SUB-002989-2024

Eau-Clair Subdivision, Resubdivision of a portion of
Lots 11, 12 & 13

**EAU-CLAIR SUBDIVISION, RESUBDIVISION OF A
PORTION OF LOTS 11, 12, & 13**

APPLICATION NUMBER 2 DATE July 18, 2024

DETAIL SITE PLAN

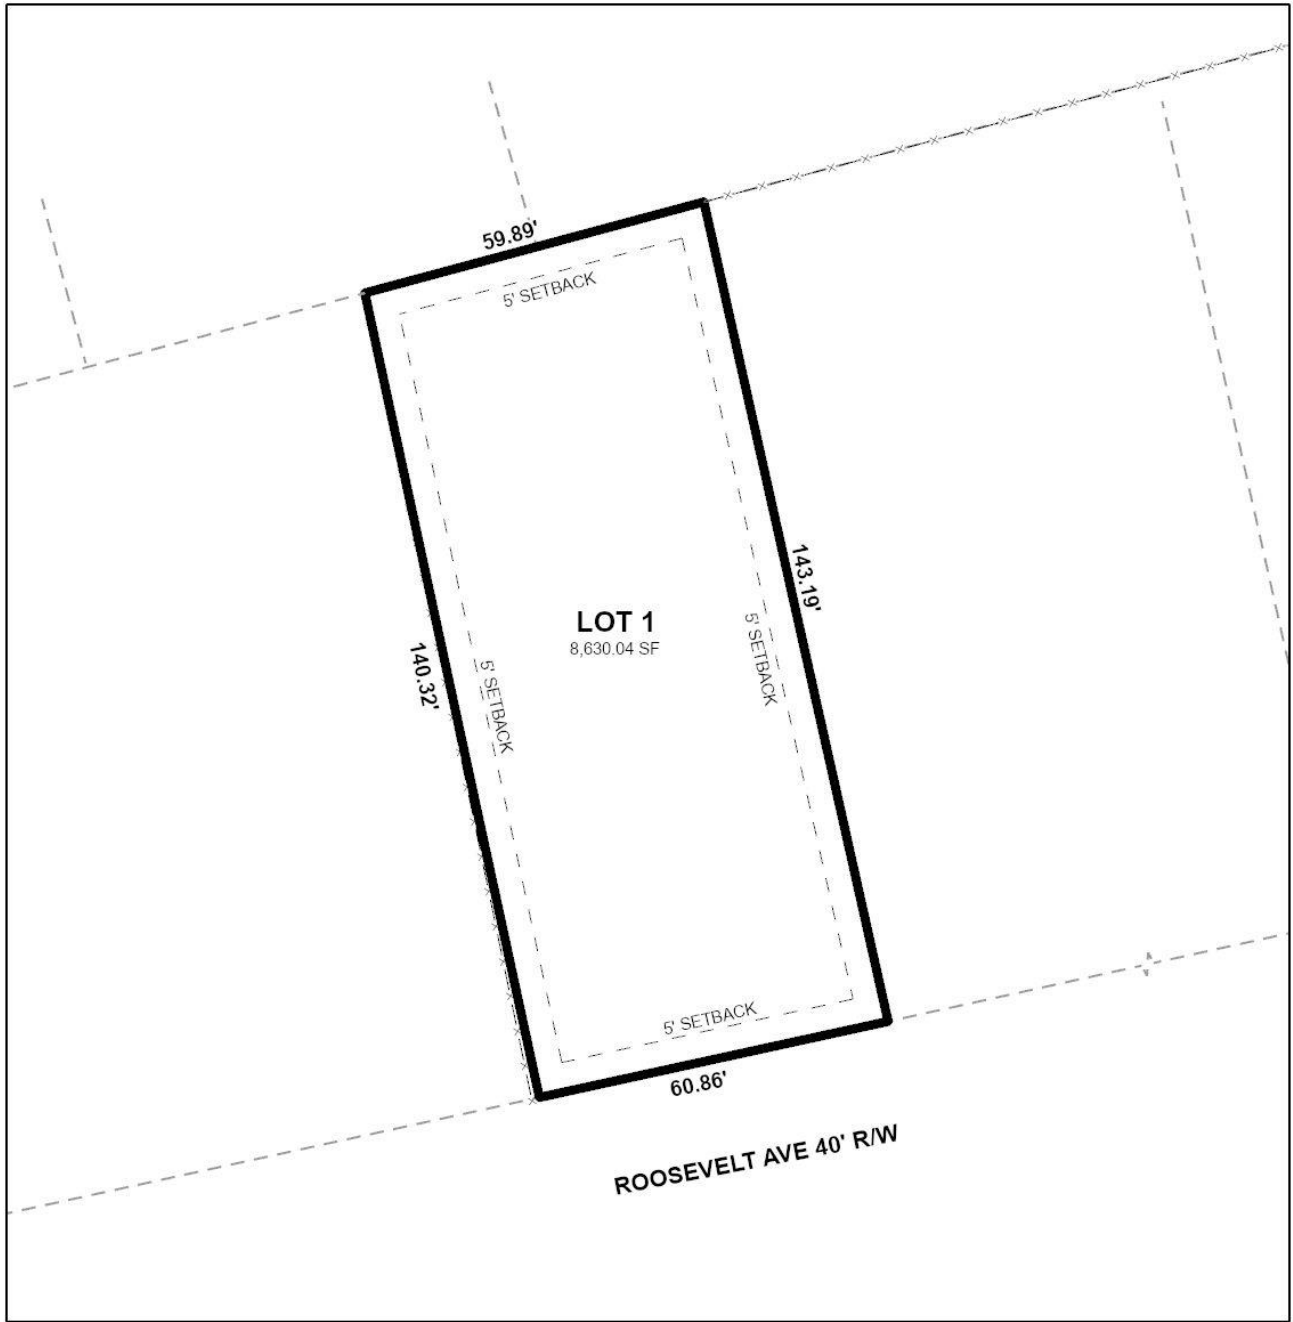
- B. Review and revise the plan and the written legal description to correct the discrepancy on the east property line distance.
- C. Review and revise the plan and the written legal description to correct the discrepancy between Roosevelt Avenue and Roosevelt Street.

- D. Add a note to the SUBDIVISION PLAT stating that as shown on the 1984 aerial photo LOT 1 will receive 1,700 sf of historical credit of existing (1984) impervious area towards stormwater detention requirement per Mobile City Code, Chapter 17, Storm Water Management and Flood Control).

The proposed lot has frontage on Roosevelt Avenue (formerly First Avenue), a minor street with curb and gutter and a substandard 40-foot right-of-way. Curb and gutter streets require a 50-foot right-of-way per Section 6.B.9 of the Subdivision Regulations, and dedication would normally be required to provide 25 feet from the centerline of Roosevelt Avenue. However, as curb and gutter are in place for Roosevelt Avenue and the South side of Roosevelt Avenue is "built out," as with many of the older areas of the city, the Commission may consider waiving the requirement of Section 6.B.9. If dedication is required, the plat should be revised to label Roosevelt Avenue with its right-of-way width after dedication.

If approved, the plat should retain the 5-foot minimum building setback line along Roosevelt Avenue as measured from any required dedication. The five-foot setback lines along the side and rear property lines should be removed on the Final Plat, if approved.

The lot size exceeds the minimum area and lot width requirements, and the information is labeled on the preliminary plat. If approved, the lot size label should be retained on the Final Plat, adjusted for any required dedication, or a table should be furnished on the Final Plat providing the same information.

1. Retention of the right-of-way width of Roosevelt Avenue if dedication is waived, or revision of the plat to label Roosevelt Avenue with its right-of-way width after any required dedication;

2. Retention of the 5-foot minimum building setback line along Roosevelt Avenue, adjusted to be measured from any required dedication;
3. Revision of the plat to remove the 5-foot building setback line along the side and rear property lines;

4. Retention of the lot size label on the Final Plat, revised to indicate the lot size after any required dedication, or the furnishing of a table on the Final Plat providing the same information;
